BRIDGE REPLACEMENT - PPCB
NHSN-020-2(143)--2R-81

SAC COUNTY - DESIGN 116/216

EXAMPLE OF TITLE SHEET WITH 4 PLAN REVISIONS.

REVISION EXAMPLE

SAC COUNTY
DESIGN NO. 116, 216
REVISION SHEET

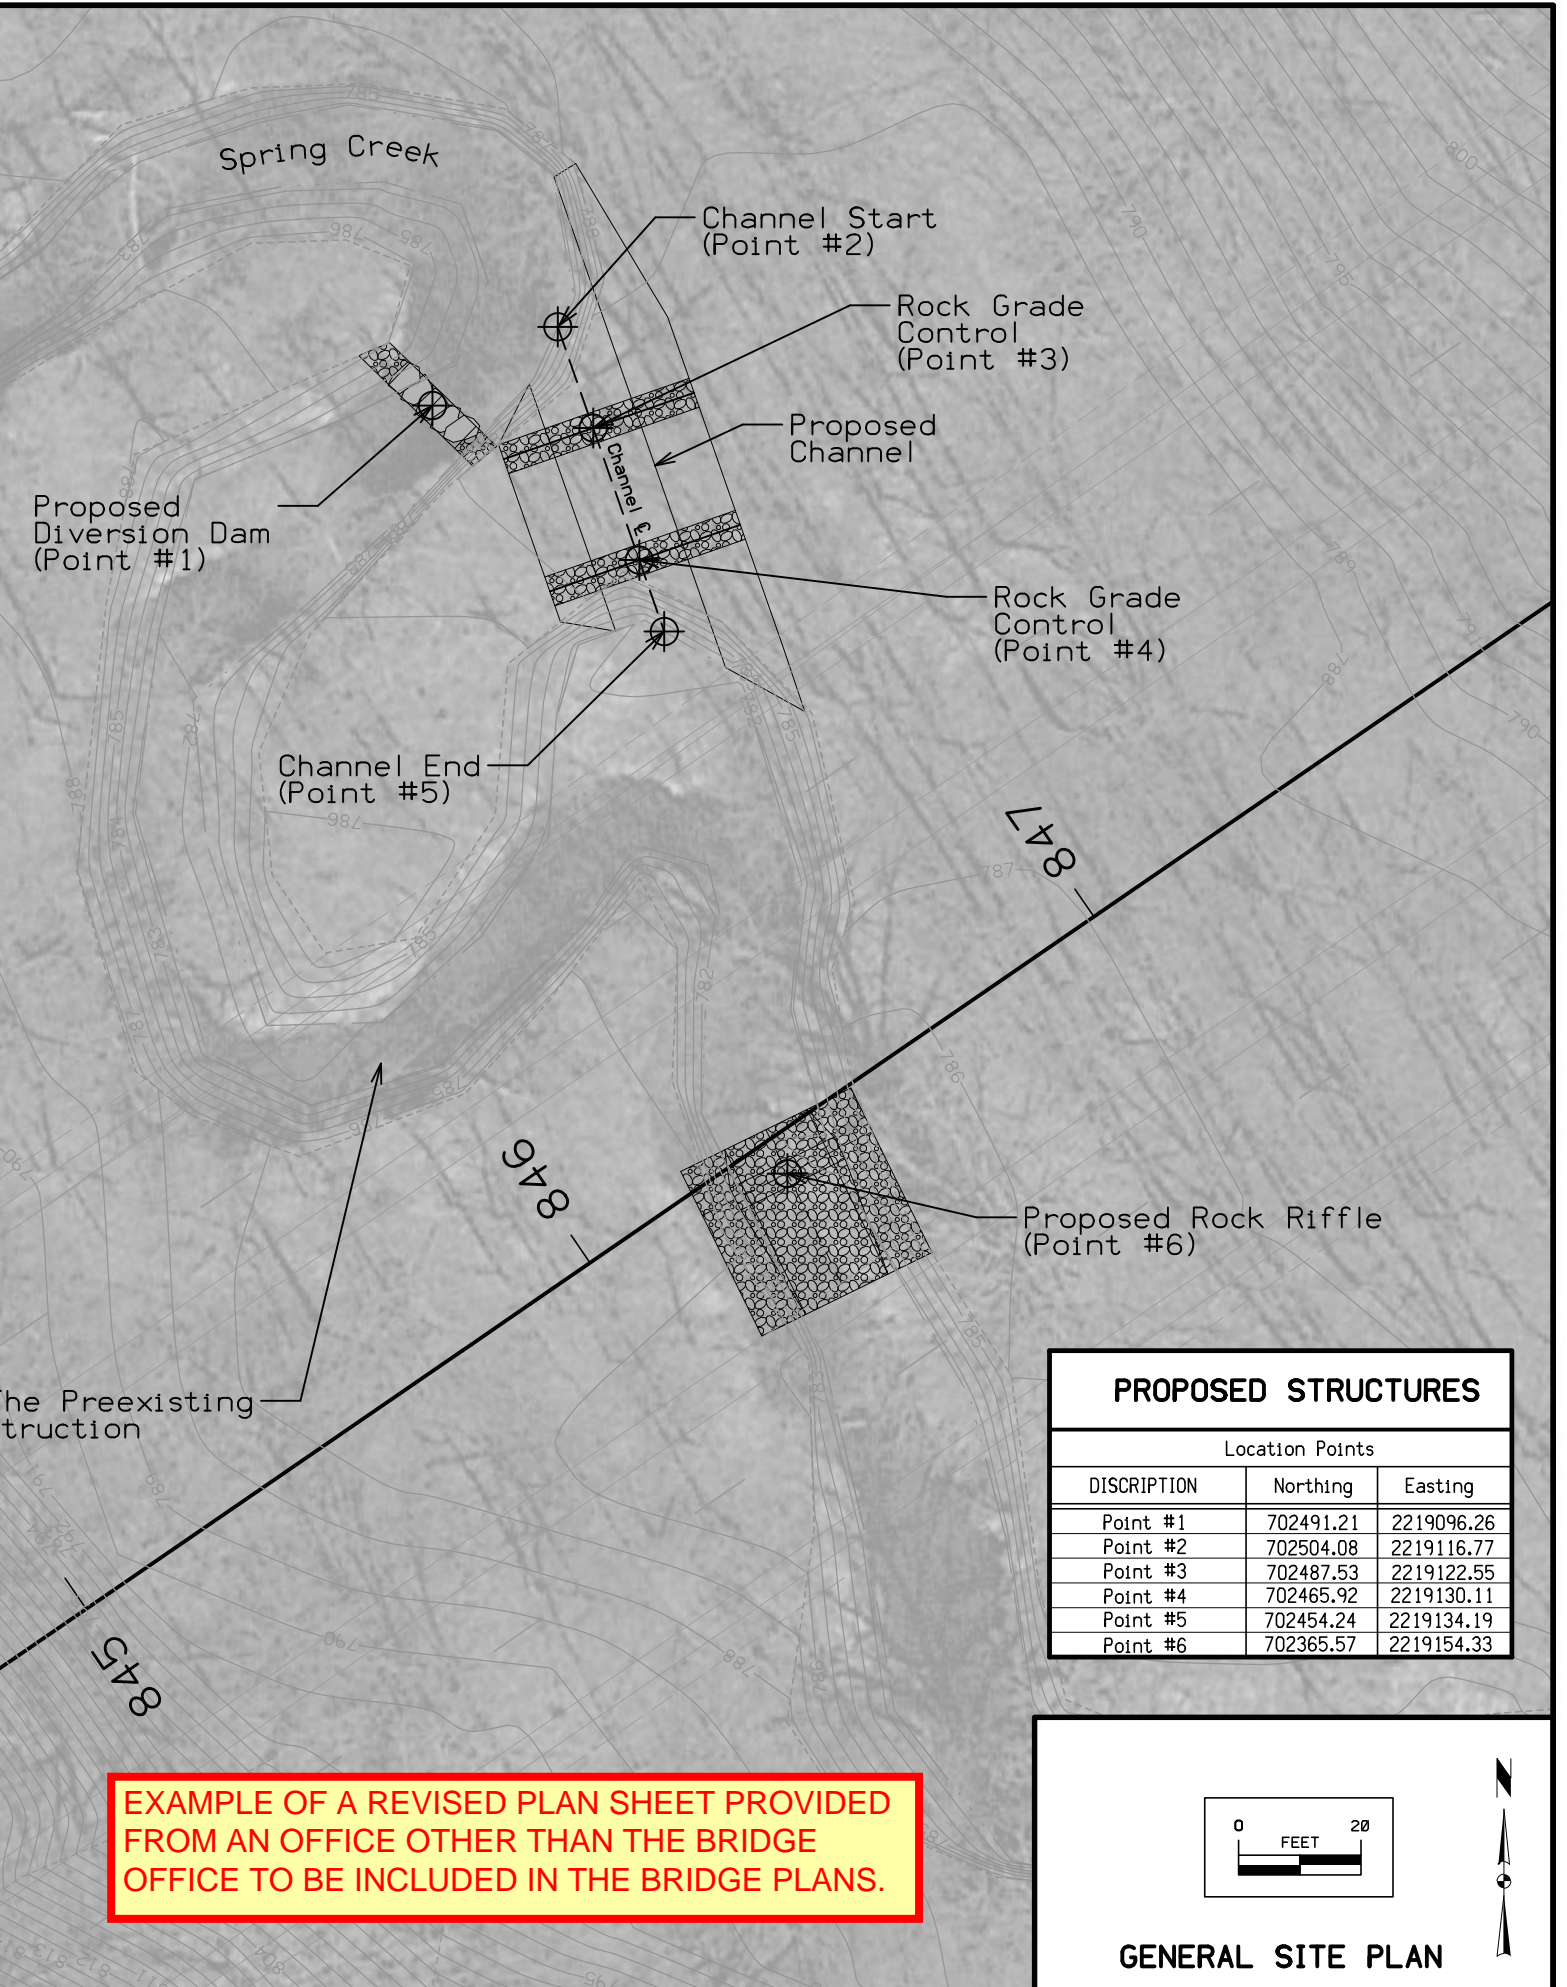
Date	Sheet No.	Description of Revisions
11/21/2017	A.1	Added listing of project revisions and signature block for revisions.
11/21/2017	MIT.1-MIT.4	Add channel straightening design and the stream mitigation required by the revision of the Section 404 Permit #: 2016-1018 in order to accommodate the construction of the bridge pier footing.
